SUNDRY NOTICES AND REPORTS ON WELLS
Do not use this form for proposals to drill or to re-enter an abandoned well. Use Form 3160-3 (APD) for such proposals.

The subject well is part of the proposed Mangum SRC 1C P&A program agreed to with the NMOCD. The attached revised procedure replaces the procedure filed with the P&A NOI submitted on 3/31/2016.

SUMMIT B #5

Re: Permanent Abandonment
Well: Summit B #5

Schematic - Proposed

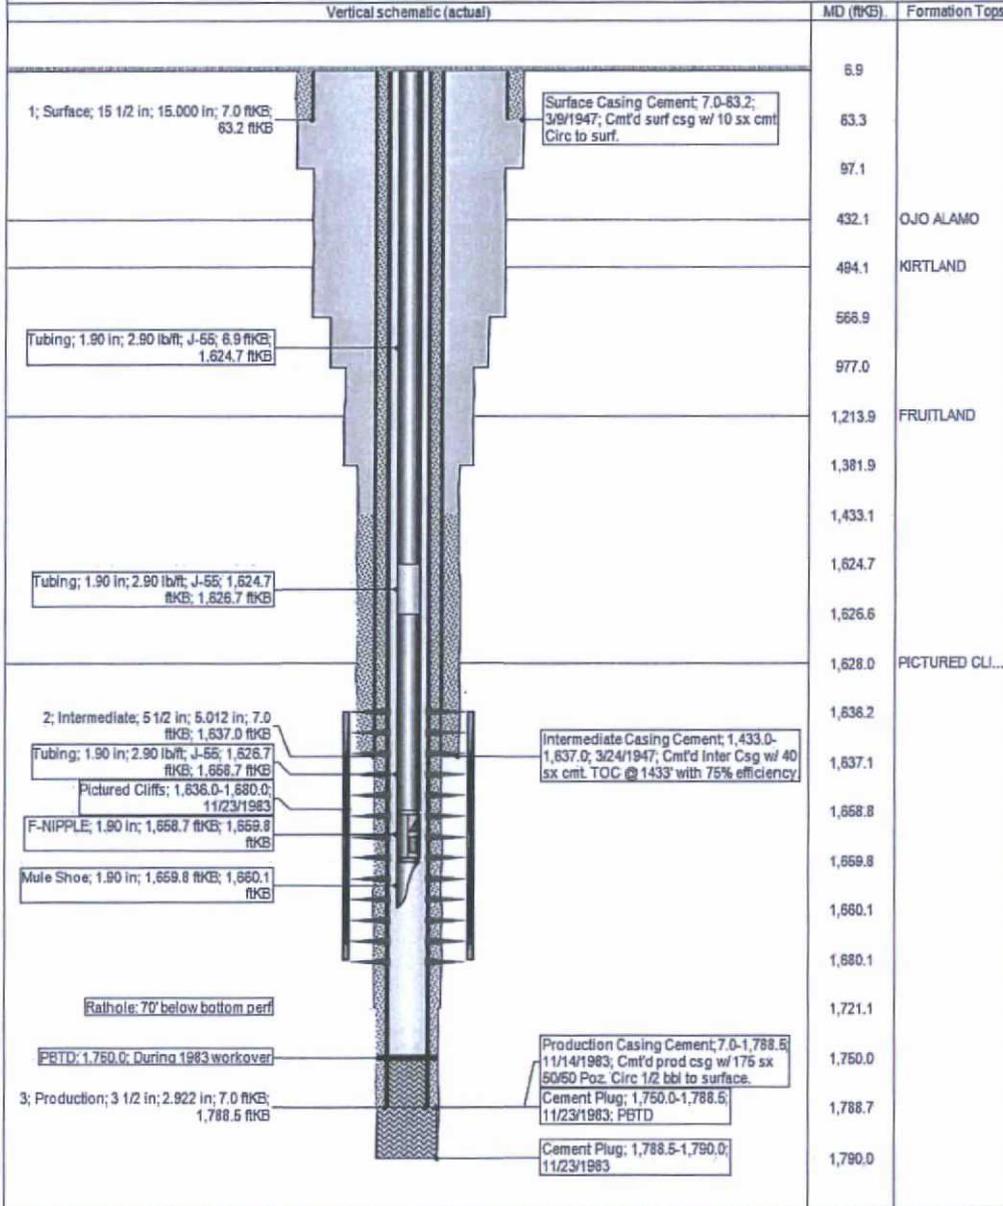
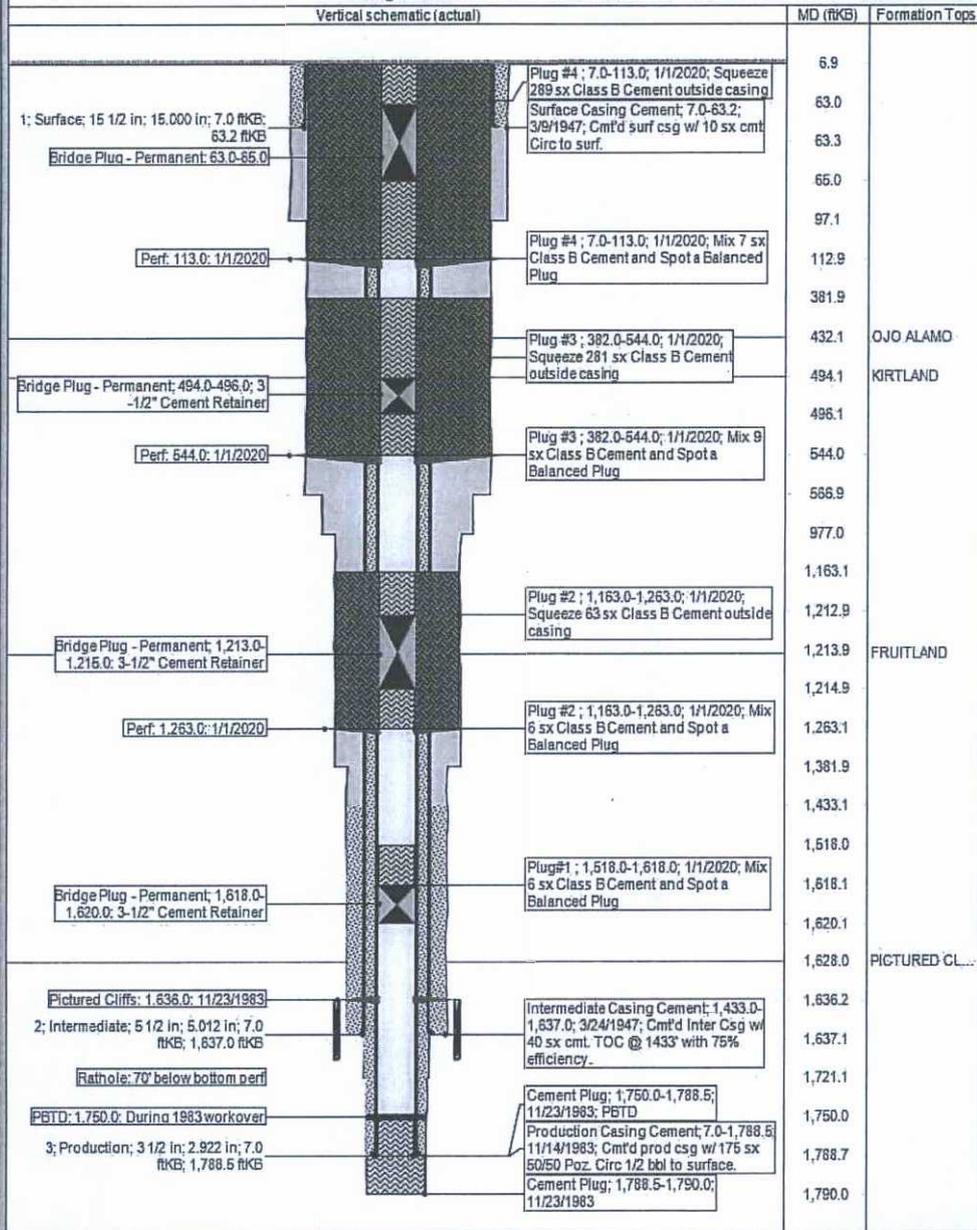
3. The following modifications to your plugging program are to be made:

- a) Set plug #1 (1586-1486) ft. to cover the Pictured Cliffs Formation top and perforations. BLM picks top of Pictured Cliffs perforations at 1636 ft.
- b) Set plug #2 (1354-1254) ft. inside/outside to cover the Fruitland Formation top. BLM picks top of Fruitland at 1304 ft.
- c) Set plug #3 (628-409) ft. inside/outside to cover the Kirtland and Ojo Alamo Formation tops. BLM picks top of Ojo Alamo at 459 ft. BLM picks top of Kirtland at 578 ft.

Operator will run CBL from CR @ 1,586 ft. to surface to identify TOC.

H₂S has not been reported at this location, however, low concentrations of H₂S (27 ppm GSV) have been reported in the NESE/4 Sec. 27, 29N, 11W.
